SERVICE INFORMATION NO. SI 40-066

GARMIN: Service Bulletin No. 0738 Rev. B

**** MANDATORY ****
SERVICE BULLETIN

NO.: 0738 Revision B

Figure 1 Failed TVS

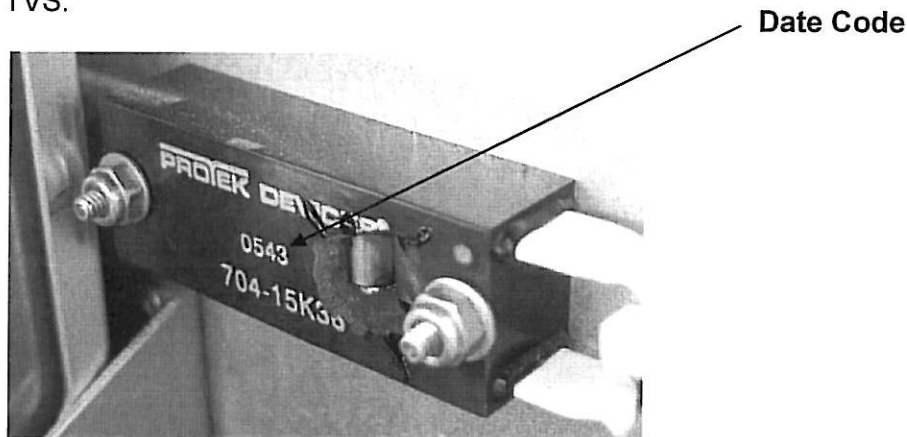
The date code can be read without removing the TVS (see Figure 1).

Replace all TVS components (regardless of the date code) that show any signs of heat damage, heat stress, or if the associated inline fuse is blown. See Figure 1 for an example of a failed TVS.

Replace all TVS components within the following date code range:

- 0543 through 0611
